**Subject:** Industry Comments on Draft Regulatory Guide DG-1327, "Pressurized Water Reactor Control Rod Ejection and Boiling Water Reactor Control Rod Drop Accidents" (Federal Register 84FR49125, dated September 18, 2019 and 7590-01-P, dated September 18, 2019, Docket ID NRC-2016-0233)

# Industry Response to Draft Regulatory Guide DG-1327 issued July 2019

Figure 4. PCMI Cladding Failure Threshold—RXA Cladding below 500 Degrees F

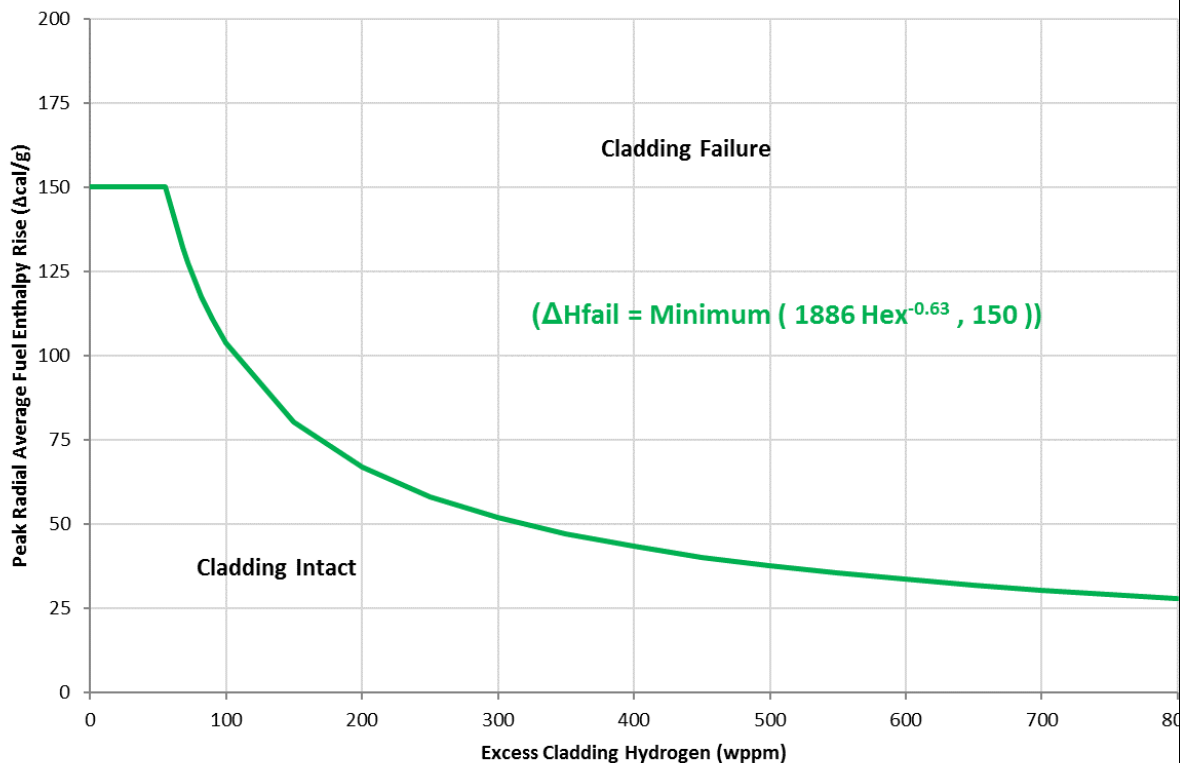
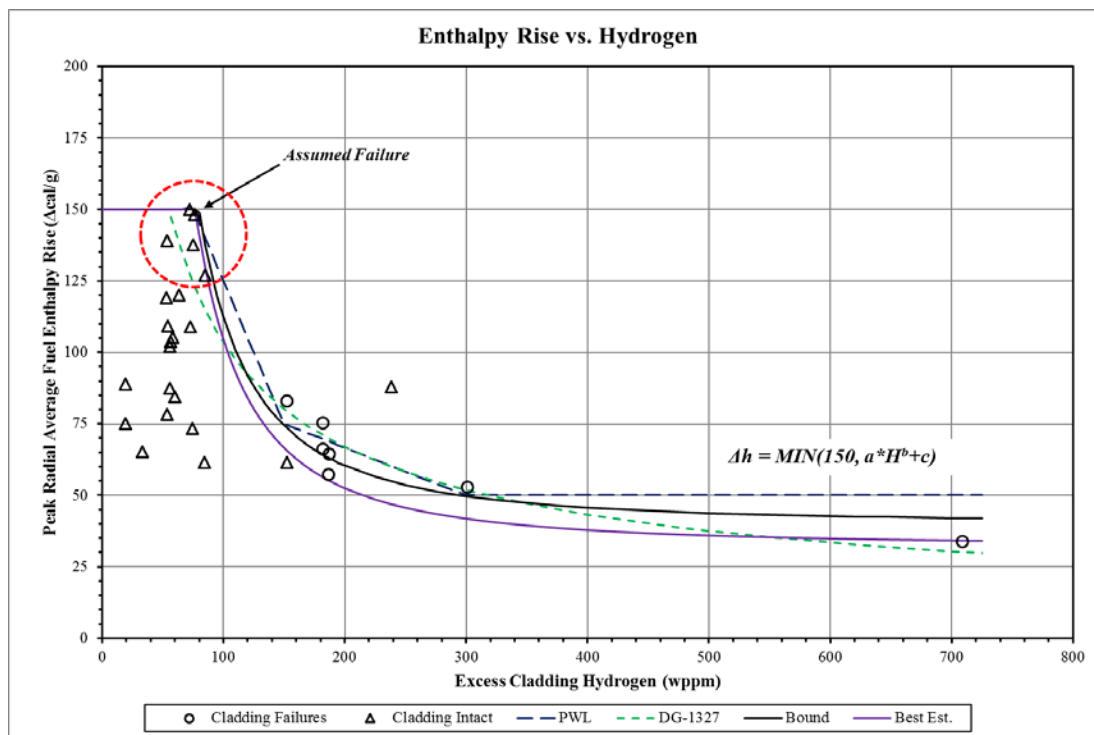
Regarding Figure 4, the staff elected to replace the previous piecewise linear (PWL) relationship with a curve fit through the data. To facilitate the curve fitting process, it was necessary to treat the highest non-failure enthalpy/hydrogen content point (72 wppm, 150 cal/g) as a presumed failure point. This presumed failure point should serve as an anchor point for the curve fit. The current curve instead omits three other non-failure points.

The primary response from a CRDA is often from the fresh fuel (i.e. lower exposure) with highly exposed fuel reacting less energetically. Thus, the purposed failure threshold is less accurate in the area of interest particularly between 55-to-100 wppm. The figure below illustrates both a best-fit and a lower bound alternative using an exponential function.

$$\Delta h = \text{MIN}(150, a * H_b + c)$$

Where  $\Delta h$  is the enthalpy change and  $H_b$  is the excess hydrogen. In these examples, the best fit coefficients are:  $a = 3.31E+5$ ,  $b = -1.83$ , and  $c = 32$ . While the lower bound coefficients are:  $a = 3.31E+5$ ,  $b = -1.83$ , and  $c = 40$ .

Please redraw the curve to encompass more of the actual non-failure data points. While this comment directly pertains to Figure 4, the same concept applies to the other fitted curves, such as Figures 2, 3 & 5.
